The RRMCS

We are in the process of responding to RFP No.: GAC.1.1/03/30/2020 Selection of Supplier for: Regional Resilient Mobile Communications System (RRMCS) to enhance Emergency Telecommunications for CDEMA and would like to request the following clarifications.

Diagram showing the RRMCs deployed in the field

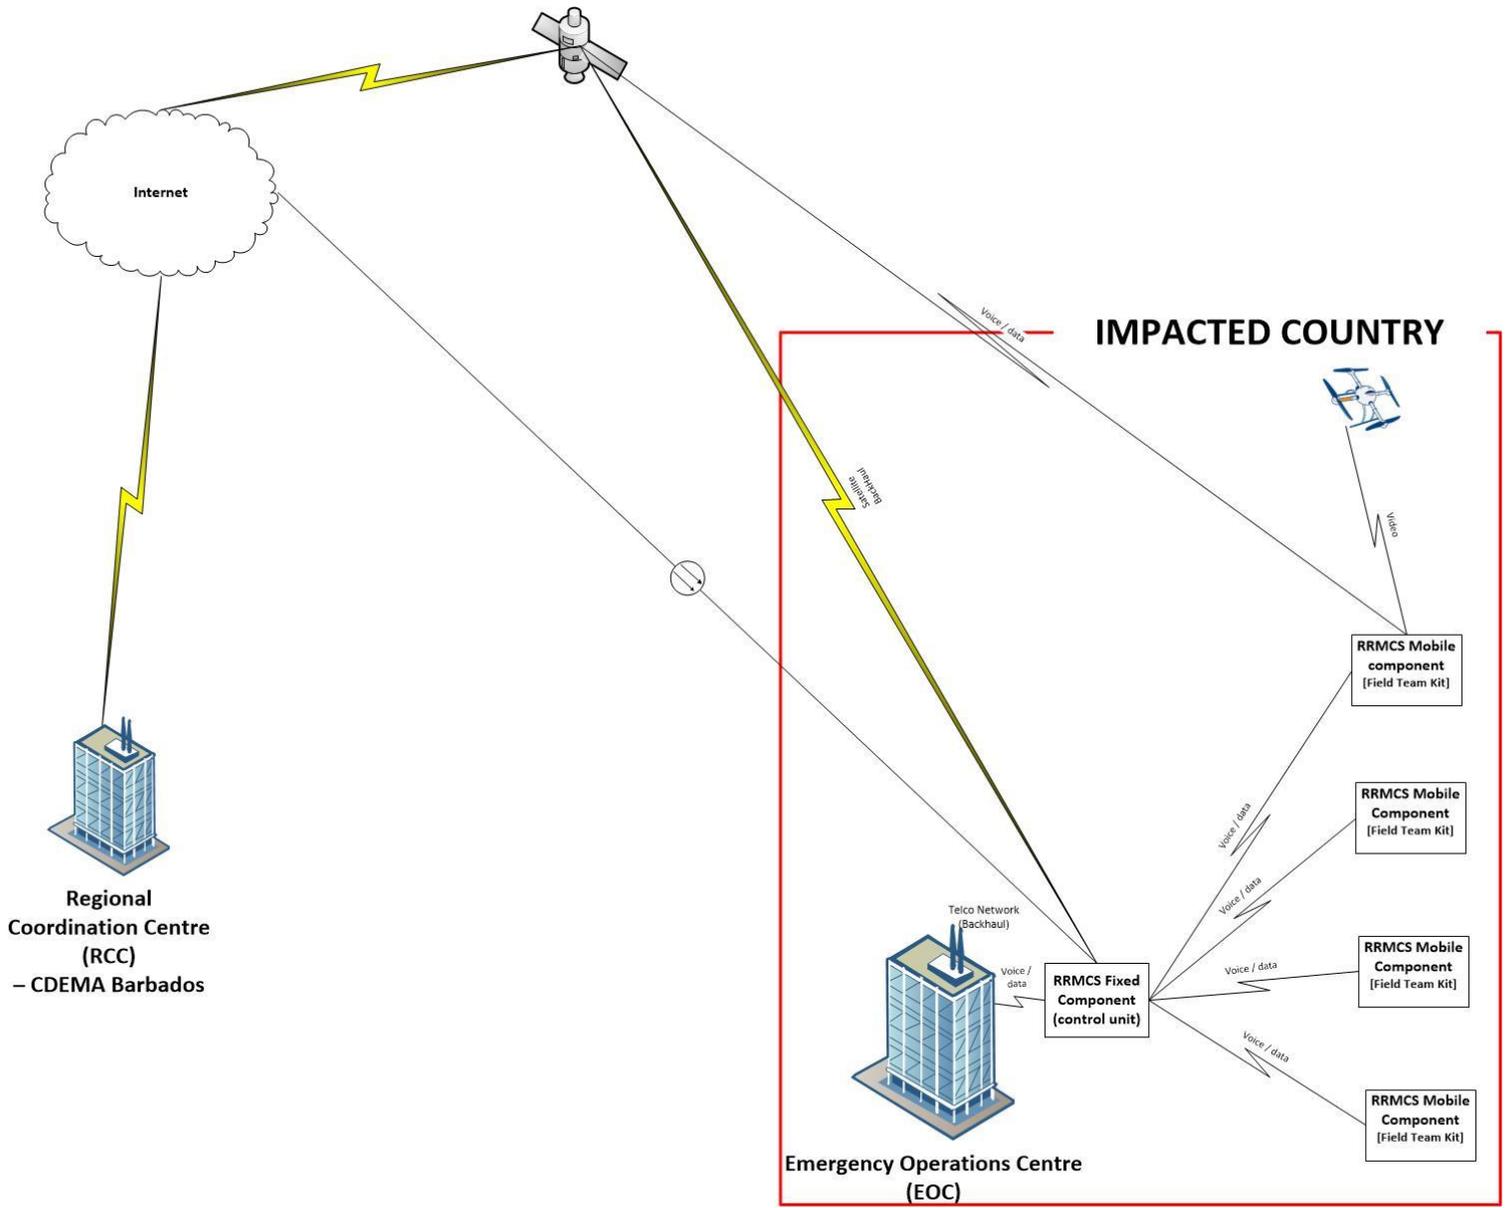
1) Have you decided on the amount of Satellite Space Segment you will need to support the Main Office HUB and the 6 Portable Mobile Units.

2) Do you know the maximum number of Hand Devices each Portable Mobile unit will be required to support? Please see summary at the beginning of the responses to the questions.

3) How many stationary VOIP Devices will be assigned/required per Portable Mobile unit? Please see summary at the beginning of the responses to the questions.

Ultimately this should be determined by the bidder based on the requirements and the bidder's expertise.
